Product Change Notification / NTDO-27QFCL926

CCB 4968 Final Notice: Qualification of MTAI as additional final test site for SST25VF512-20-4C-SAE and SST25VF512-20-4C-SAE-T catalog part numbers (CPN) available in 8L SOIC (.150in) package.

CCB 4968

Tube

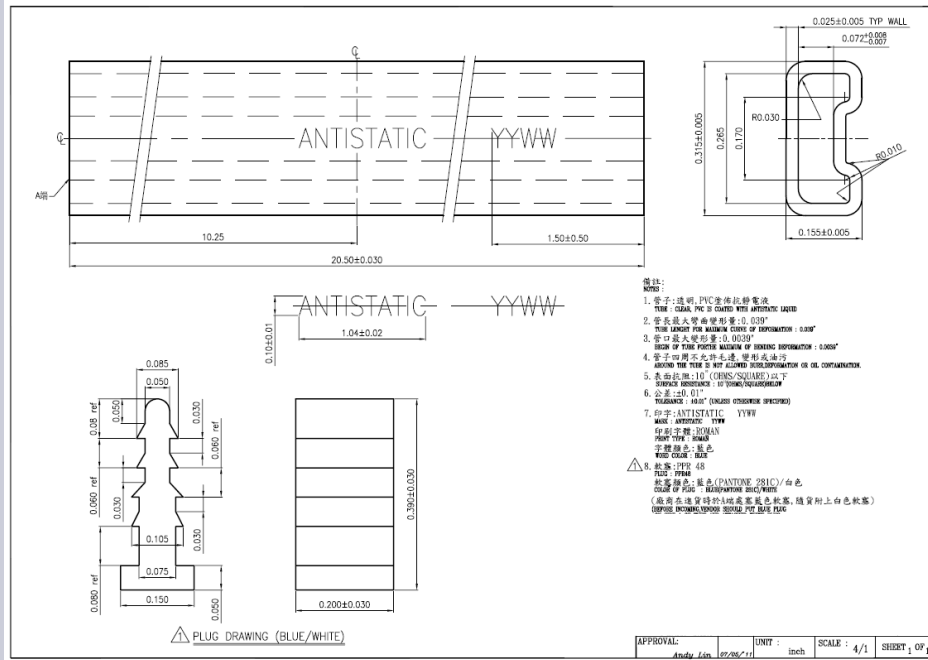
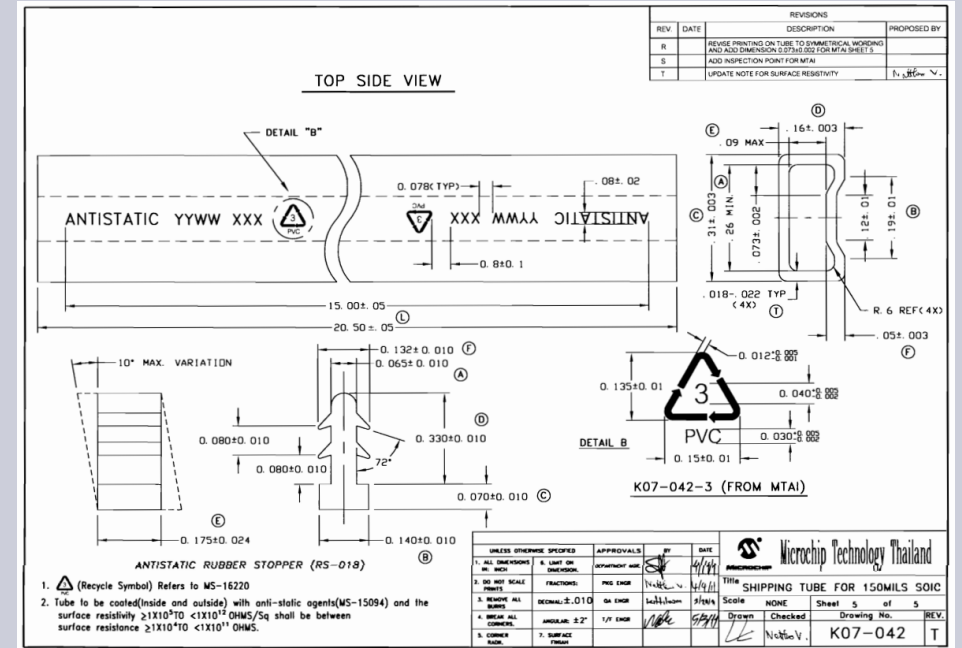
Length	Color
20.50 ±0.03 inch	Clear

Length	Color
20.50 ±0.05 inch	Clear

Carrier tape

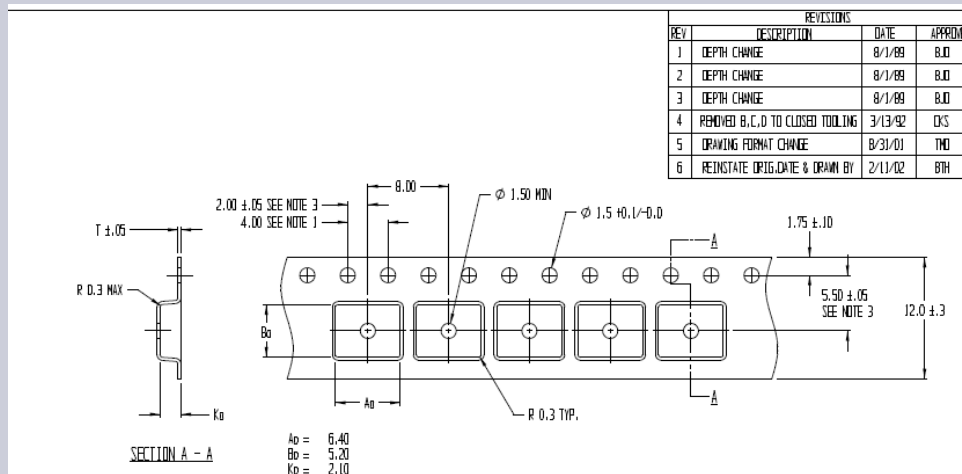
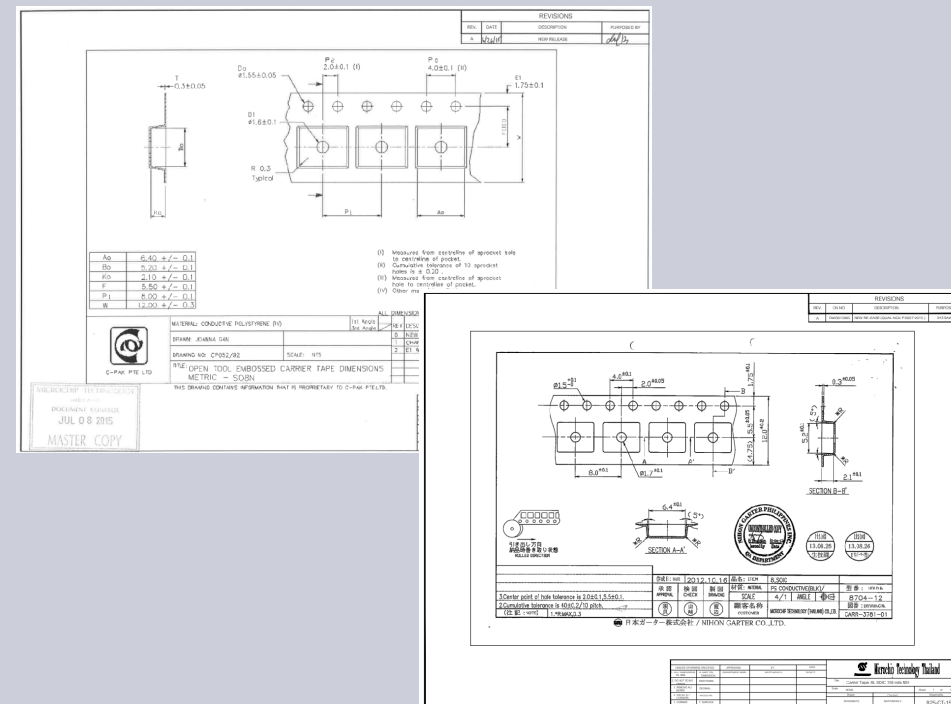
Plant	Supplier Part	W (mm.)	P (mm.)	A0 (mm.)	B0 (mm.)	K0 (mm.)	K1 (mm.)	Thickness
KYE	SOIC08-AC400.P1	12.00 ± 0.30	8.00 ± 0.10	6.40 ± 0.10	5.20 ± 0.10	2.10 ± 0.10	-	0.30 ± 0.05

Plant	Supplier Part	W (mm.)	P (mm.)	A0 (mm.)	B0 (mm.)	K0 (mm.)	K1 (mm.)	Thickness
MTAI	SO8N PS3 22X10CY L410 W12 (CL)	12.00 ± 0.30	8.00 ± 0.10	6.40 ± 0.10	5.20 ± 0.10	2.10 ± 0.10	-	0.30 ± 0.05
	8704-12	12.00 ± 0.30	8.00 ± 0.10	6.40 ± 0.10	5.20 ± 0.10	2.10 ± 0.10	-	0.30 ± 0.05

Cover tape

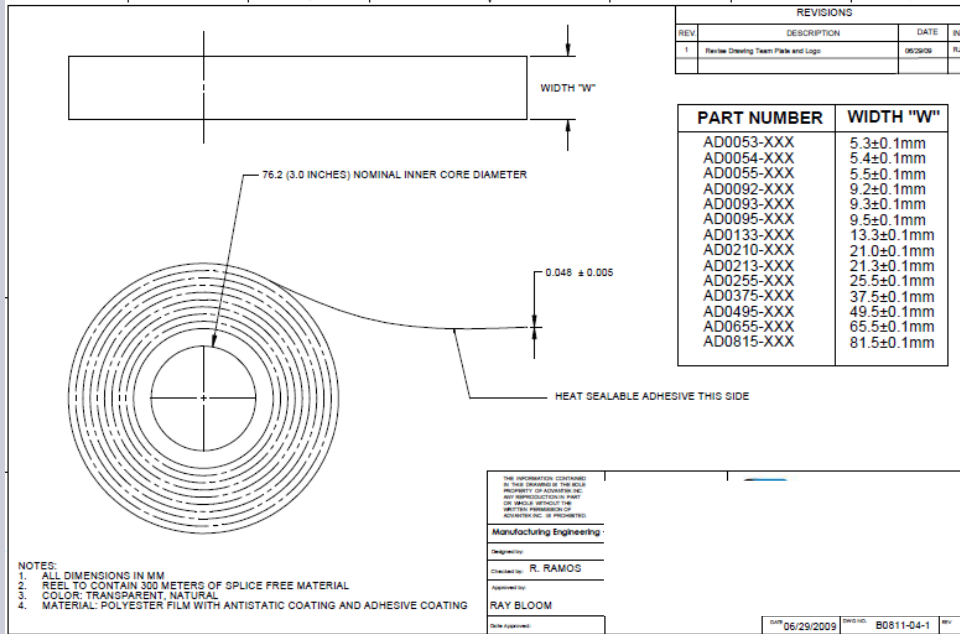
Supplier Part	Width W (mm.)	Thickness T (mm.)	Color	Sealing Methodology
AD0093-300	9.3±0.1	0.048±0.005	Transparent	Heat Seal

Supplier Part	Width W (mm.)	Thickness T (mm.)	Color	Sealing Methodology
CSL-Z7302	9.05 +0.05/-0.15	0.050 ±0.010	Clear	Heat Seal

Plastic Reel

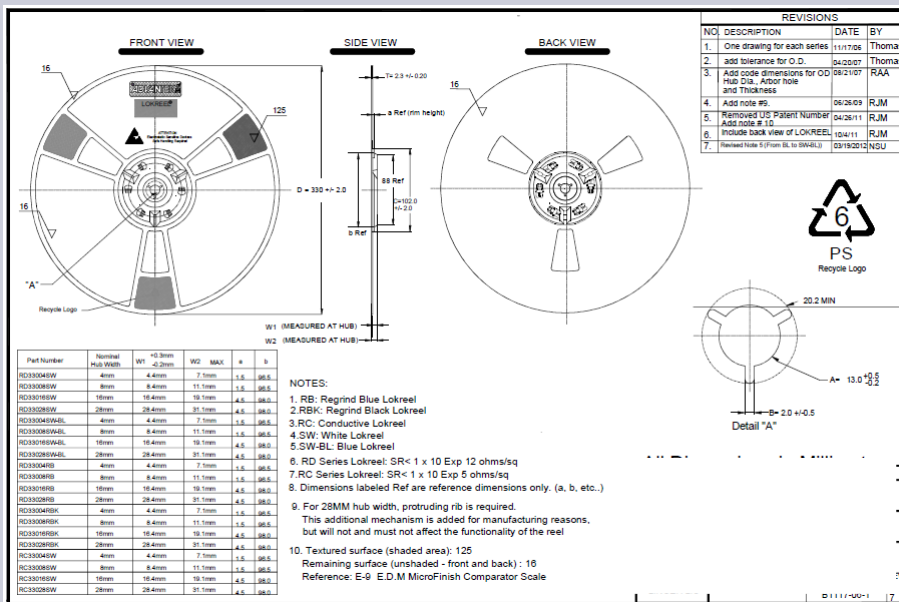
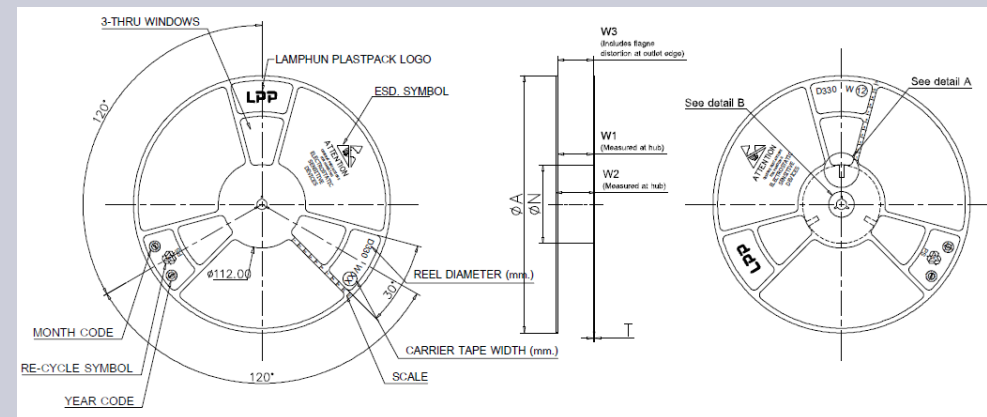
Supplier Part	Reel Diameter (mm.)	Reel Hub Size (mm)	Reel Width Max (mm.)	Color.
RD33004RB + RD33008RB	330 ±2.0	102±2.0	7.1 + =18.20 11.1	Regrind Blue

Supplier Part	Reel Diameter (mm.)	Reel Hub Size (mm)	Reel Width Max (mm.)	Color.
R13-12-04-E	330 ±2.0	100 ±2.0	18.40	Dark Blue

T/R Packing Method
(Dry Pack)

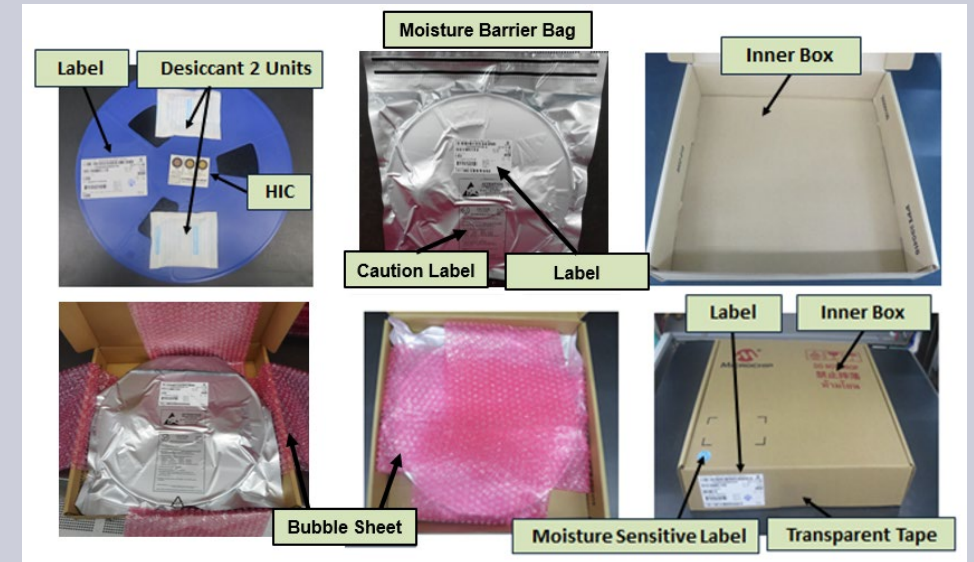
KYE	MTAI								
<p>T/R Packing Method (No Dry Pack)</p>	 <table border="1" data-bbox="606 1006 937 1078"> <thead> <tr> <th>BAG WIDTH</th> <th>BAG LENGTH</th> </tr> </thead> <tbody> <tr> <td>410mm</td> <td>460mm</td> </tr> </tbody> </table>	BAG WIDTH	BAG LENGTH	410mm	460mm	 <table border="1" data-bbox="2025 442 2382 514"> <thead> <tr> <th>BAG WIDTH</th> <th>BAG LENGTH</th> </tr> </thead> <tbody> <tr> <td>370 mm</td> <td>420 mm</td> </tr> </tbody> </table> <p>(MTHAI No inner Box)</p>	BAG WIDTH	BAG LENGTH	370 mm	420 mm
BAG WIDTH	BAG LENGTH									
410mm	460mm									
BAG WIDTH	BAG LENGTH									
370 mm	420 mm
